AMENDMENTS TO THE DRAWINGS

REMARKS

FIG. 5

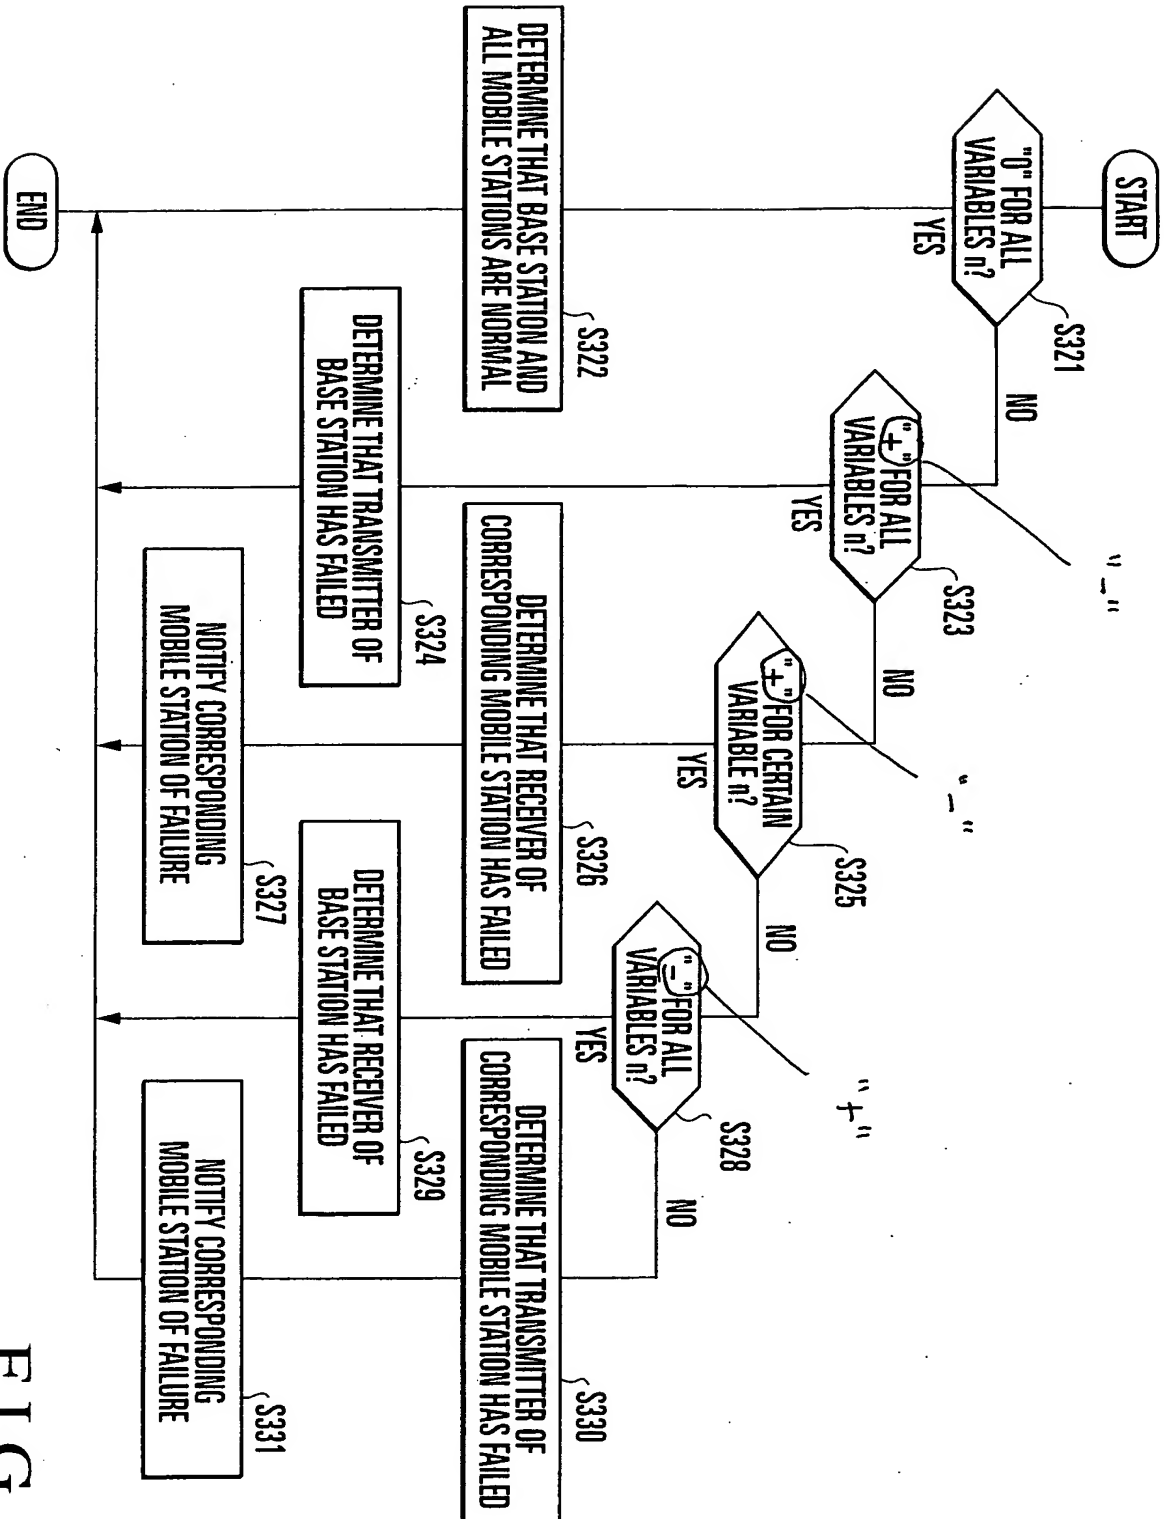
Please replace the drawing sheets currently on file with the attached replacement sheets, the changes to Figures 5 and 6 are shown on the attached annotated sheets.

Claims 5 and 6 were rejected under 35 U.S.C. 112, first paragraph. It is believed that the confusion is caused by the fact that the "corrected" Figure 5 that accompanied the First Preliminary Amendment filed with the application papers is itself incorrect. Figure 5 as corrected in the Article 34 Amendment in the International stage shows a "-" sign in each of steps S323 and S325 and a "+" sign in step S328. Unfortunately, through an inadvertent error, Figure 5 was "corrected" in the First Preliminary Amendment to show a "+" sign in each of steps S323 and S325 and a "-" sign in step S328. To bring the drawings in the present case back to where they should be, taking into account the Article 34 amendment, new formal drawings are filed herewith. These drawing sheets correct Figure 5 so as to read as that figure was amended in the International stage. Figure 6 has also been amended to include the label "Prior Art."

Among the changes made in that Preliminary Amendment were changing "--" to "+" and "+" to "--" at pages 22 and 23. This was done to conform the English translation with the changes made in the Article 34 amendment at the International stage and to Figure 5. This section of the specification should read just as Applicant requested it be amended at pages 2 and 3 of the First Preliminary Amendment.

In view of the above, Applicant is not amending the "--" and "+" signs in the manner requested at Page 3 the Office Action. The way the specification reads currently at pages 22 and 23, taking into account the changes in the First Preliminary Amendment, is correct, in view of the "re-corrected" Figure 5.

It is believed the correction of Figure 5 obviates the Section 112, first paragraph, rejection of claims 5 and 6.
